TRANS/WP.29/GRE/2004/28/Rev.1
20 January 2005

PROPOSAL FOR DRAFT AMENDMENTS TO REGULATION No. 48
(Installation of lighting and light-signalling devices)

Transmitted by the Informal Group "Adaptive Front-lighting Systems (AFS)"

Apparent surfaces of lighting units 1 through 11 of an AFS (example)

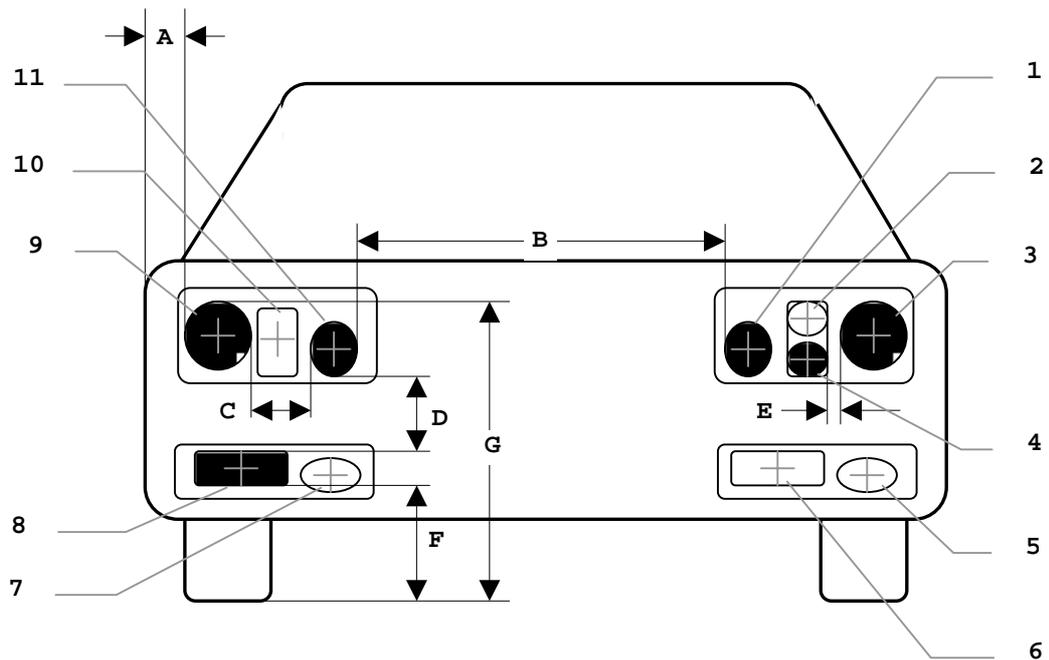
6.22.4.1.2. Additional lighting units, if any, on either side of the vehicle shall be positioned at a distance not exceeding 140 mm 7/ in horizontal direction (E in the figure) and 400 mm in vertical direction above or below (D in the figure) from the nearest lighting unit;

6.22.4.1.3. None of the additional lighting units described in paragraph 6.22.4.1.2. above shall be positioned lower than 250 mm (F in the figure) nor higher than *indicated in paragraph 6.2.4.2. of this Regulation* (G in the figure) above the ground;

the outer edge of the apparent surface of at least one lighting unit on each side of the vehicle shall not be more than 400 mm from the extreme outer edge of the vehicle (A in the figure); and,

the inner edges of the apparent surfaces in the direction of the reference axes shall be not less than 600 mm apart. This does not apply, however, for M₁ and N₁ category vehicles; for all other categories of motor vehicles this distance may be reduced to 400 mm where the overall width of the vehicle is less than 1300 mm.

7/ In case of additional "two symmetrically placed lighting units" the horizontal distance may be 200 mm (C in the figure).
